**Proposal #11: 1440-15-71, WISC 2021 227
Fond du Lac - Plymouth
USH 151 – Seven Hills Road
STH 23
Fond du Lac County**

This is Addendum No. 01, which provides for the following:

ADDENDUM NO. 1

Addendum No. 01
ID 1440-15-71
Revised Sheet 2
February 26, 2021

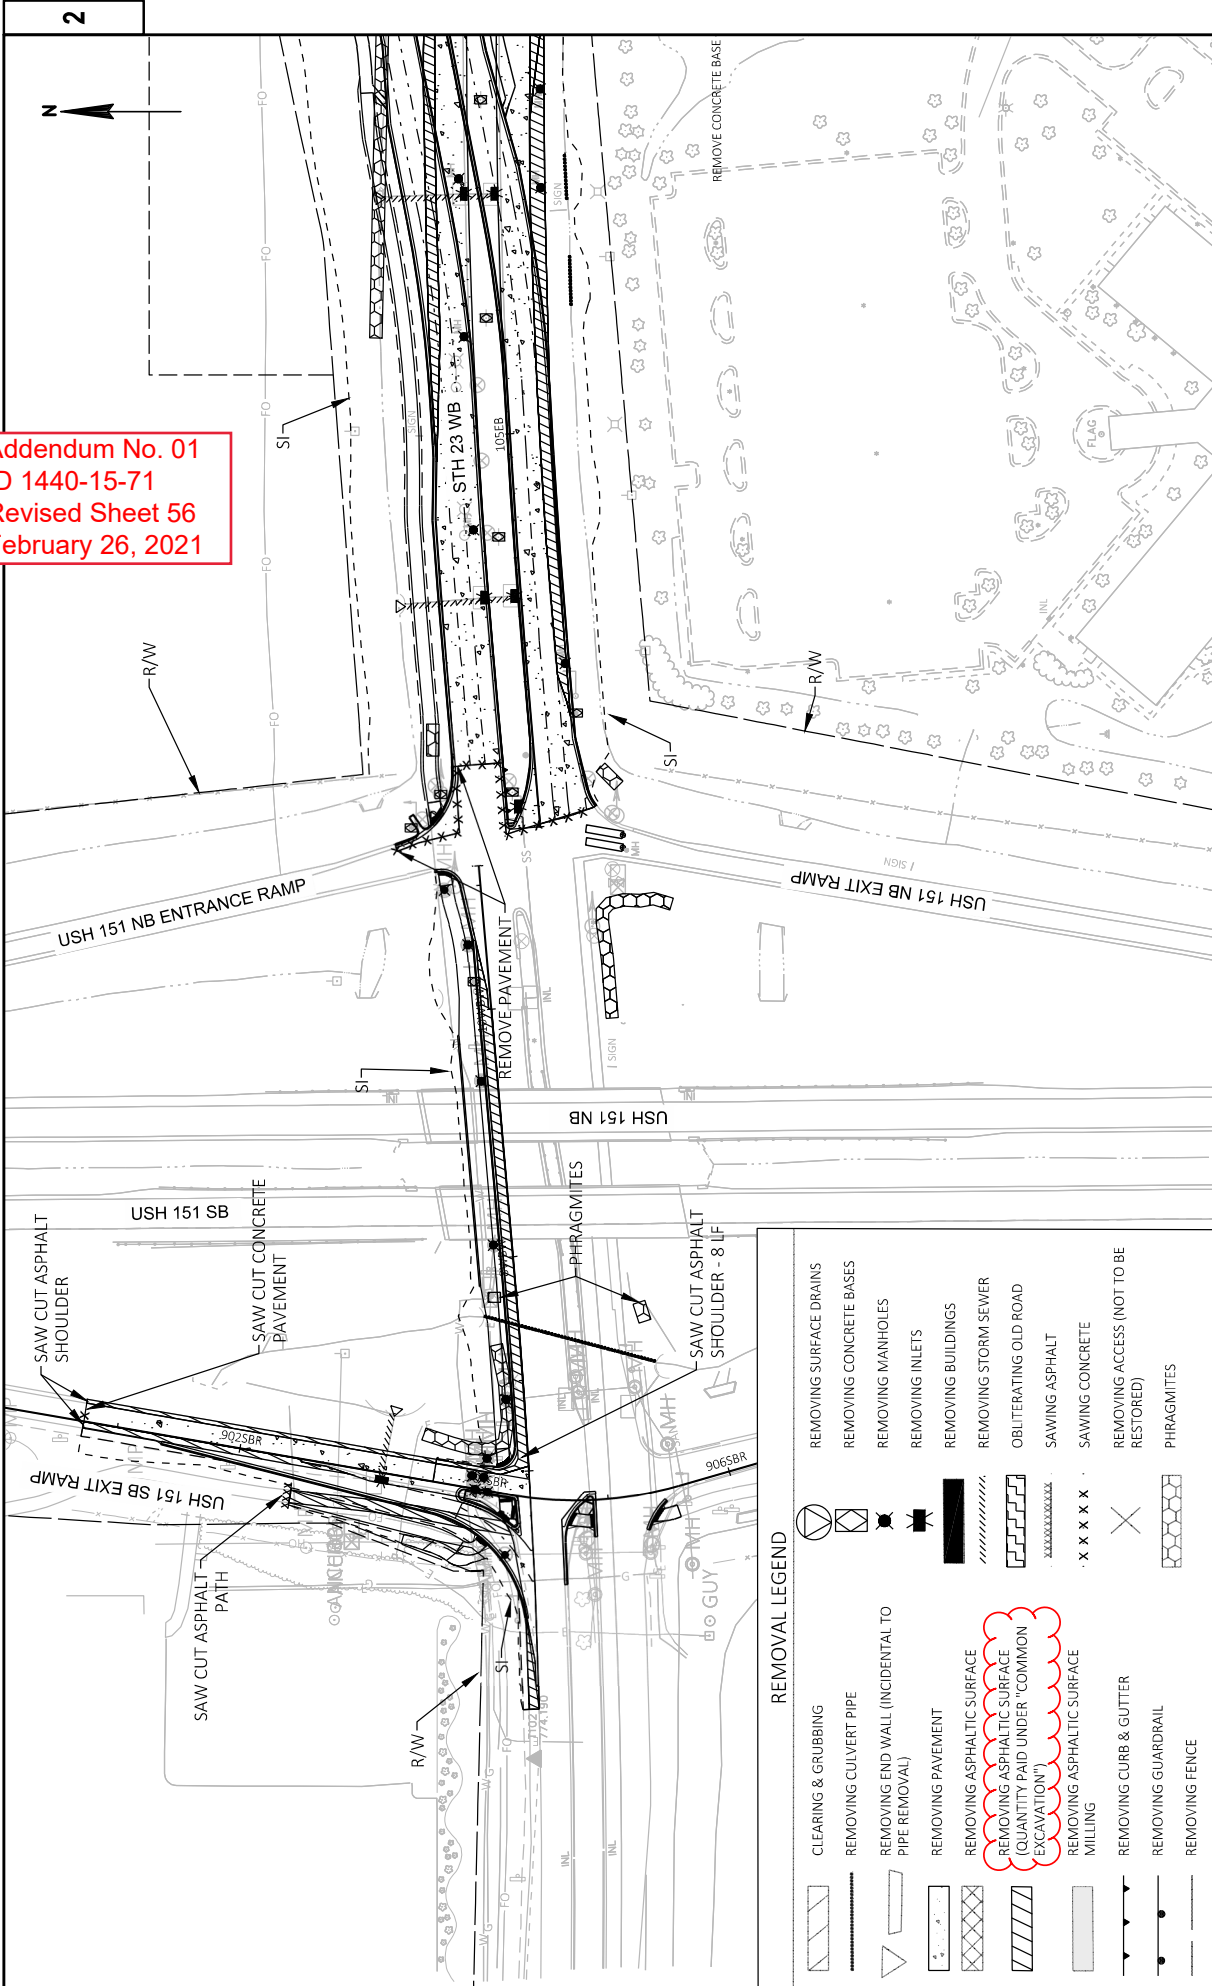
Revised Plan Sheets	
Plan Sheet	Plan Sheet Title (brief description of changes to sheet)
2	General Notes – Utility Contacts Changed
54	Construction Detail: Station 245+11 WB Entrance – Portion of driveway changed to concrete from gravel.
56-66	Removal Plan – Various Changes Due to contractor questions and Real Estate coordination
75-85	Removal Plan – Various Changes Due to contractor questions and Real Estate coordination
146	Plan Details: STH 23 – Driveway from sheet 54 is shown and the driveway type indicator changed.
147	Plan Details: STH 23 – Driveway from sheet 54 is shown and the driveway type indicator changed.
870	Miscellaneous Quantities – Removing Asphaltic Surface Increased for areas of Fill
874	Miscellaneous Quantities – Property Removals revised to eliminate one building and a line that had no quantity on it
882	Miscellaneous Quantities – Concrete Driveway Quantity Table Updated
992	Miscellaneous Quantities – Drilled Shafts added to Type 1 Signs Table
